Entergy Nuclear Operations, Inc.
Pilgrim Nuclear Power Station
600 Rocky Hill Road
Plymouth, MA 02360

SUBJECT: Entergy Nuclear Operations, Inc.
Pilgrim Nuclear Power Station
Docket No. 50-293
License No. DPR-35

Technical Specifications Amendment Request to Revise the Surveillance
Requirements for the High Pressure Coolant Injection (HPCI) and Reactor Core
Isolation Cooling (RCIC) systems.

LETTER NUMBER: 2.06.025

Figure 1

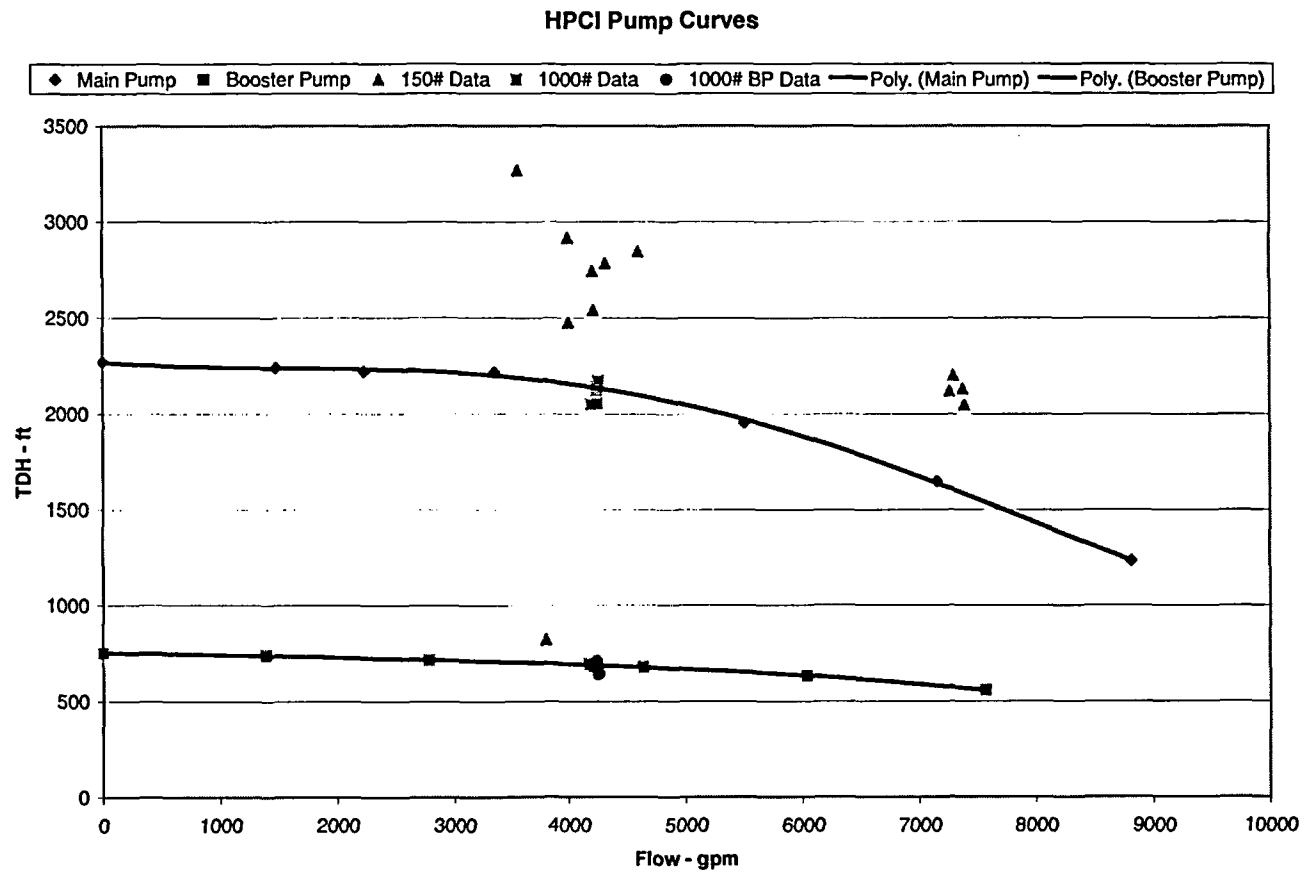
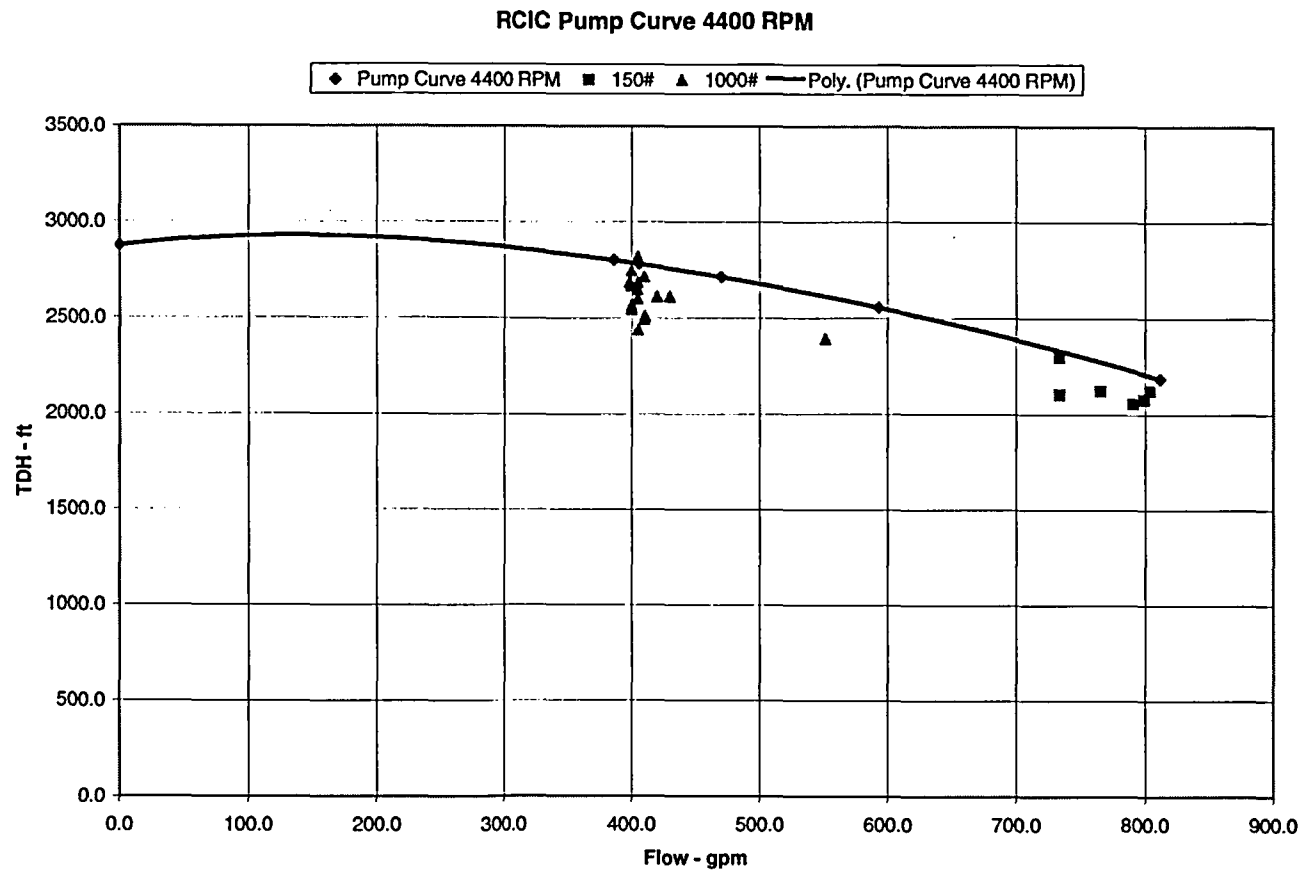
Figures 1 and 2 are curves that were developed from data collected for each system during testing to show performance of the system at each end of the design pressure range. The figures corroborate the principle that system performance at high pressure is indicative of system performance at low pressure. This principle will not change unless the system is modified or degradation is present in the system that alters its performance.
